SIE Inc.

Technical Memo

Subject. DRIVE Noise countermeasures.

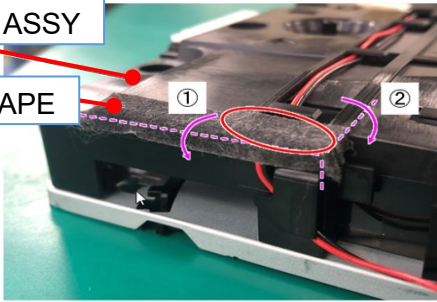
Description. Reassembling the DRIVE may cause chattering noise when playing the disk.
Please attach tape and take measures.
FRAME COMPL ASSY has three shapes, which are explained below.

FFC FASTING TAPE
Paste so that it wraps in from the directions of ① and ②.

Cutting

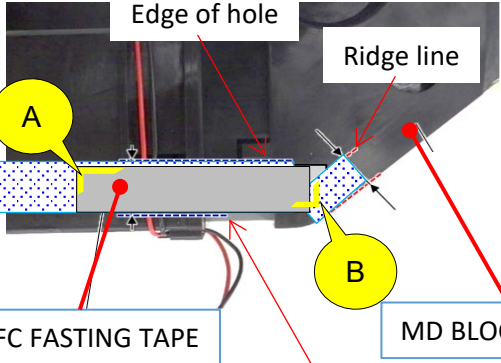
Paste corners A and B of FFC FASTING TAPE without sticking out of  area.

By changing the shape of FRAME COMPL ASSY A-5021-379-D,
chattering noise can be eliminated.
Noise countermeasures using tape are no longer required.
